HISTORIC AND DESIGN REVIEW COMMISSION

HDRC CASE NO: 2023-508
ADDRESS: 111 AUBREY ST
LEGAL DESCRIPTION: NCB 928 BLK 2 LOT 3 ARB A8
ZONING: D, H
CITY COUNCIL DIST.: 1
DISTRICT: RIO-3, Individual Landmark
APPLICANT: Tammara Alacron | 111 Aubrey LLC
OWNER: Tammara Alacron | 111 Aubrey LLC
TYPE OF WORK: Construction of a 450 square-foot rear addition
APPLICATION RECEIVED: December 21, 2023
60-DAY REVIEW: February 19, 2024
CASE MANAGER: Bryan Morales

REQUEST:

The applicant is requesting a Certificate of Appropriateness for approval to construct an approximately 450 square-foot rear addition.

② **FIRST FLOOR DEMOLITION**
1/4" = 1'-0"

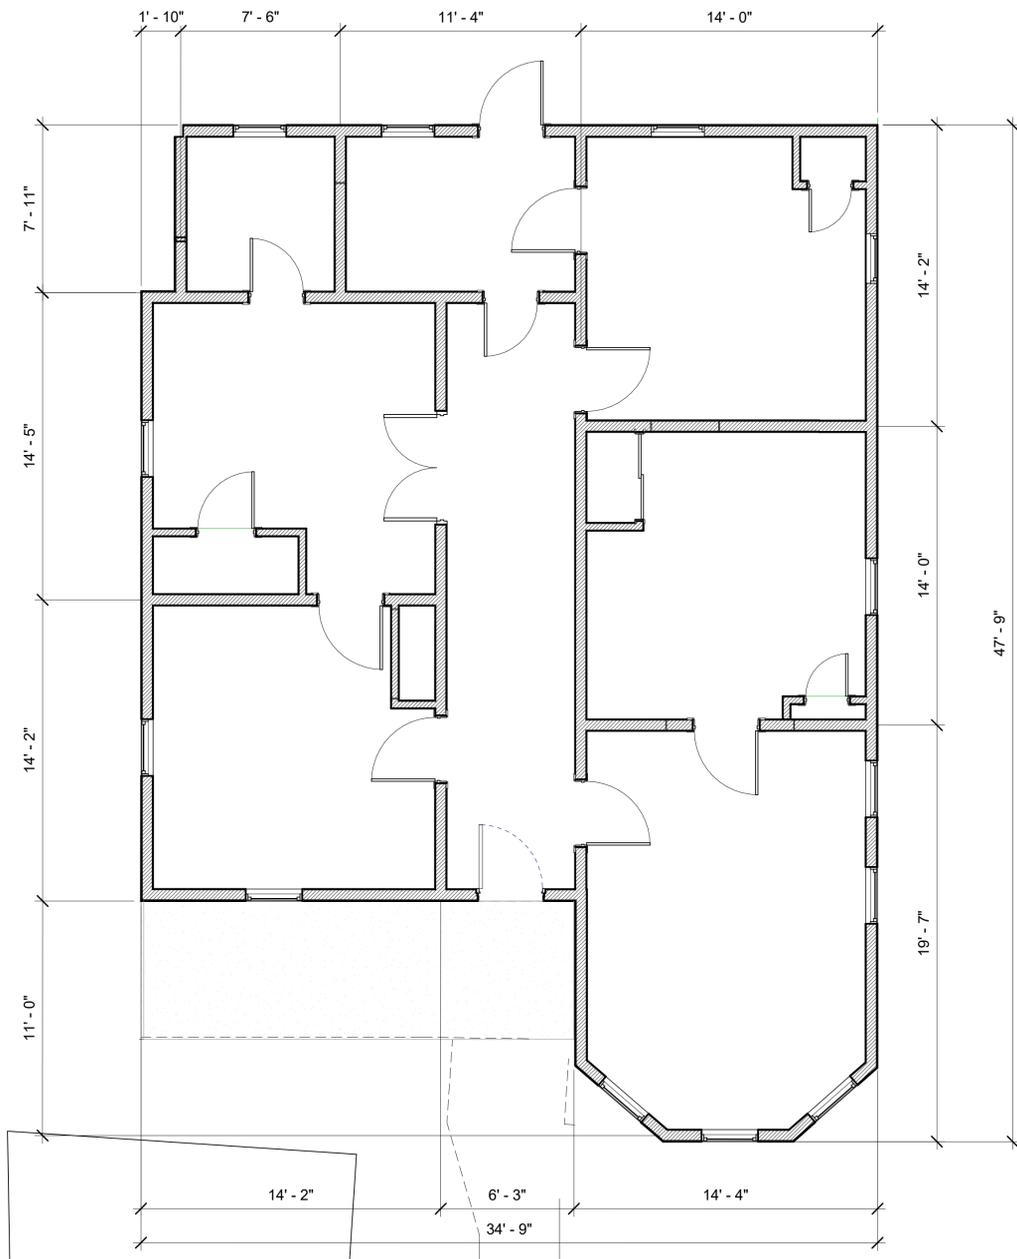
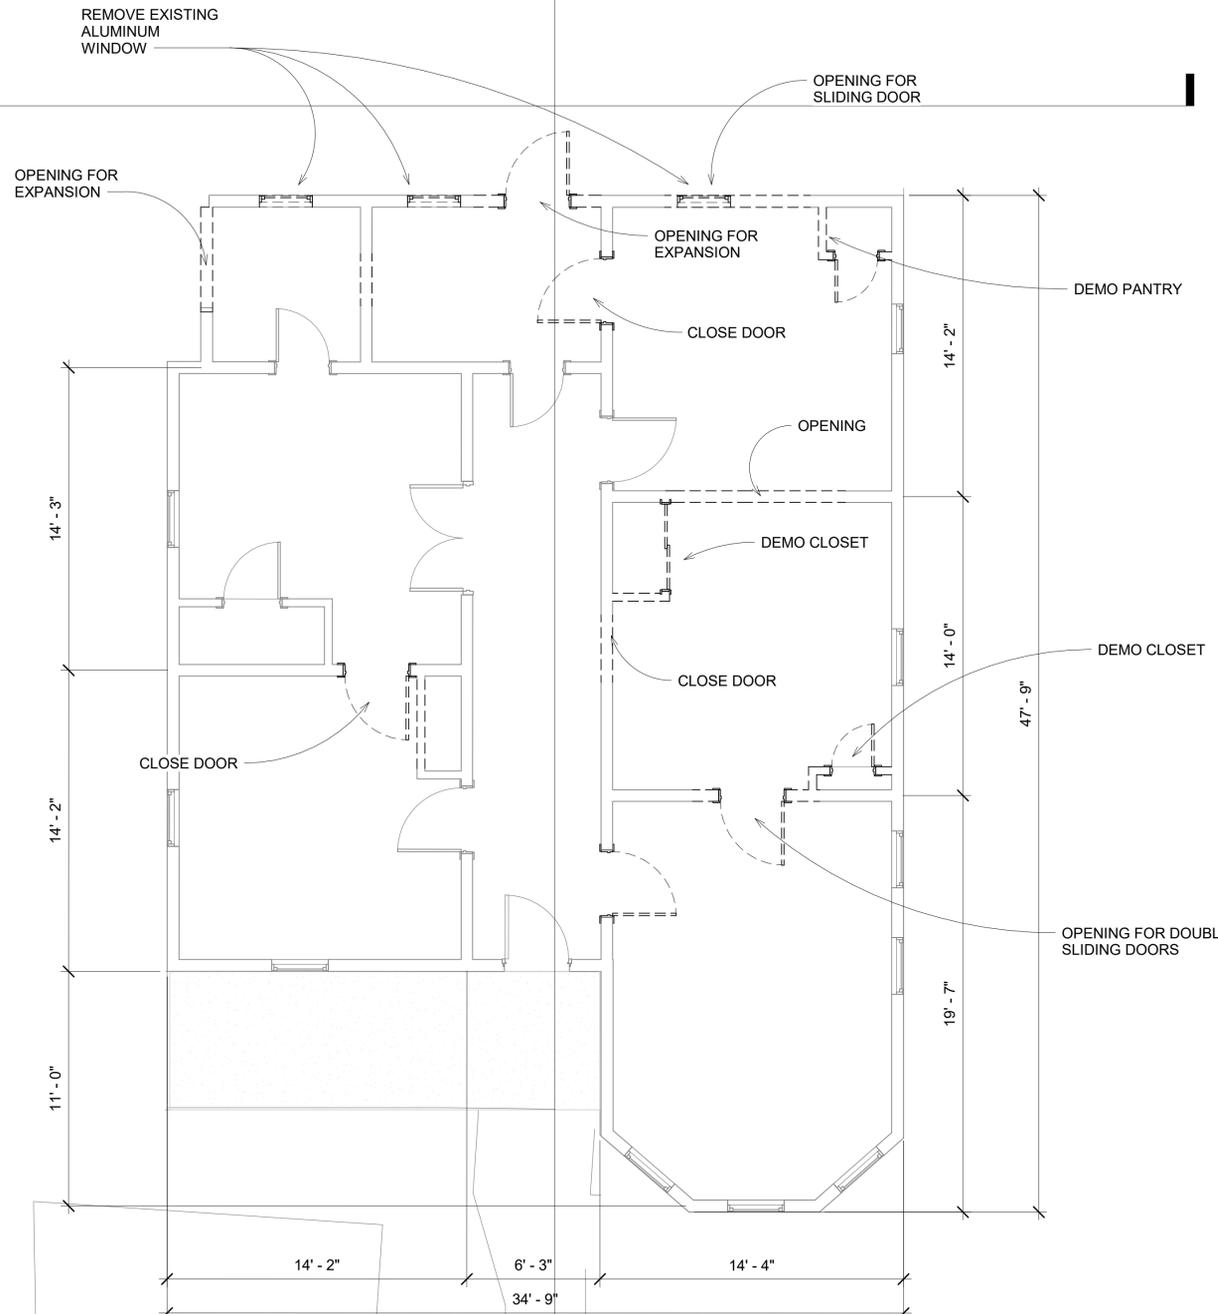
- b. CONSTRUCTION DOCUMENTS (EXISTING STRUCTURE) – The applicant has submitted construction documents that show modifications to the existing structure’s fenestration pattern. The applicant has confirmed to staff by email that no modifications to the existing structure’s fenestration pattern will occur. Updated construction documents will be required prior to the issuance of a Certificate of Appropriateness and permit from Development Services Department.

- i. That the applicant submit to staff updated construction documents that accurately depict the existing structure.
- ii. That the applicant install a standing seam metal roof featuring panels that are 18 to 21 inches wide, seams that are 1 to 2 inches high, a crimped ridge seam, and match the current finish or a standard galvalume finish. Panels should be smooth without striation or corrugation. Ridges are to feature a double-munch or crimped ridge configuration; no vented ridge caps or end caps are allowed. All chimney, flue, and related existing roof details must be preserved. An inspection must be scheduled with OHP staff prior to the start of work to verify that the roofing material matches the approved specifications. No modifications to the roof pitch or roof form are requested or approved at this time.

① East
1/4" = 1'-0"

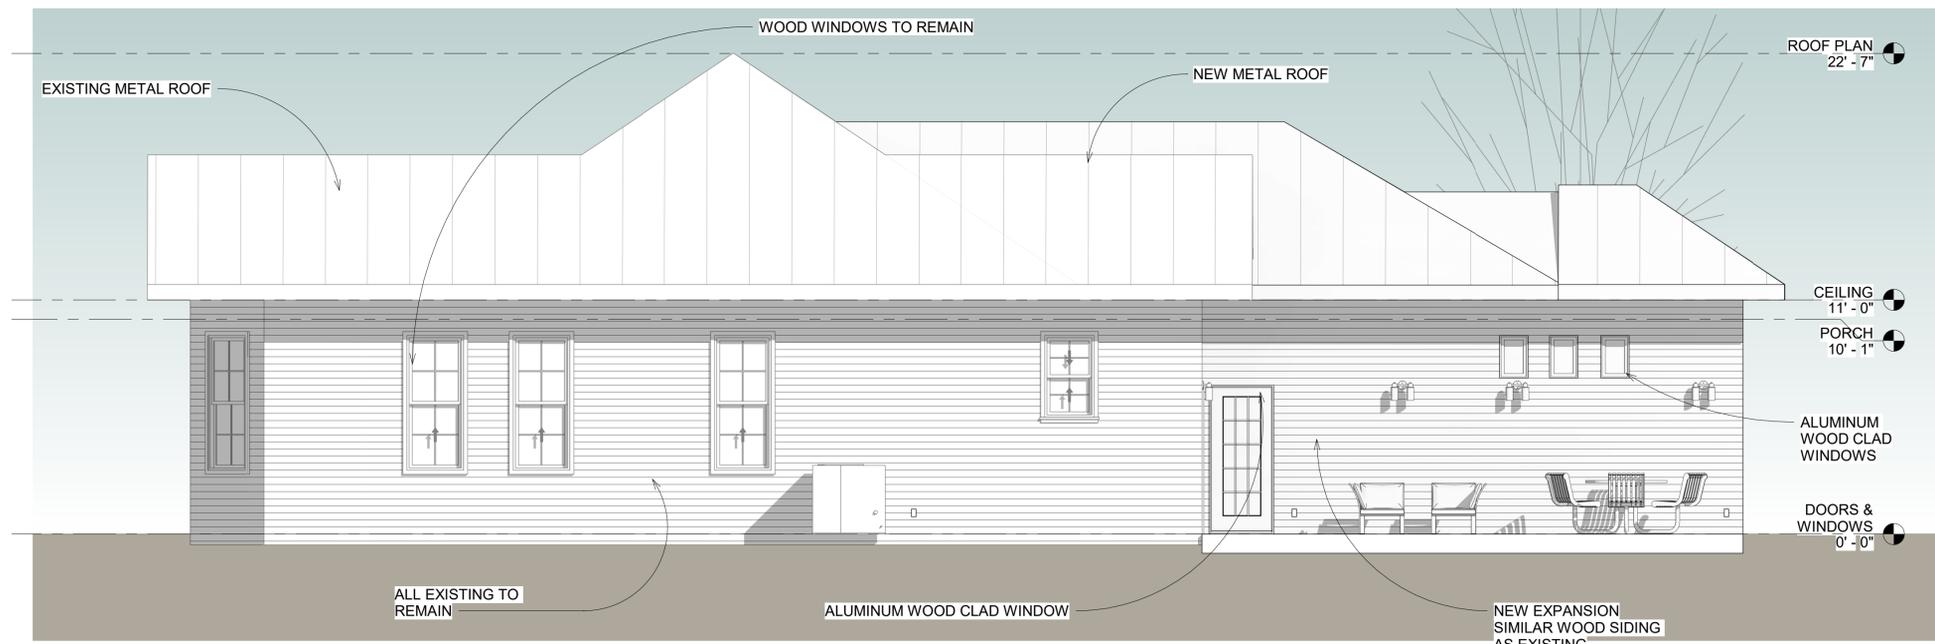
- h. REAR ADDITION (RELATIONSHIP OF SOLIDS AND VOIDS) – According to the Historic Design Guidelines, new construction and additions should incorporate window and door openings with a similar proportion of wall to window space as typical with nearby historic facades. Windows, doors, porches, entryways, dormers, bays, and pediments shall be considered similar if they are no larger than 25% in size and vary no more than 10% in height to width ratio from adjacent historic facades. Avoid blank walls, particularly on elevations visible from the street. No new façade should exceed 40 linear feet without being penetrated by windows, entryways, or other defined bays. Staff finds the proposed fenestration pattern conforms to guidelines; however, the applicant should modify the proposed window openings on the plan east elevation to incorporate a similar proportion of wall to window space as existing on the structure.

- iii. That the applicant use a more traditional window opening and configuration on the plan east elevation of the proposed rear addition.
- iv. That the applicant install windows that meet staff's standard window stipulations and submits updated specifications to staff for review and approval. The windows should feature an inset of two (2) inches within facades and should feature profiles that are found historically within the immediate vicinity. Meeting rails must be no taller than 1.25" and stiles no wider than 2.25". White manufacturer's color is not allowed, and color selection must be presented to staff. There should be a minimum of two inches in depth between the front face of the window trim and the front face of the top window sash. This must be accomplished by recessing the window sufficiently within the opening or with the installation of additional window trim to add thickness. Window trim must feature traditional dimensions and architecturally appropriate sill detail. Window track components must be painted to match the window trim or concealed by a wood window screen set within the opening.
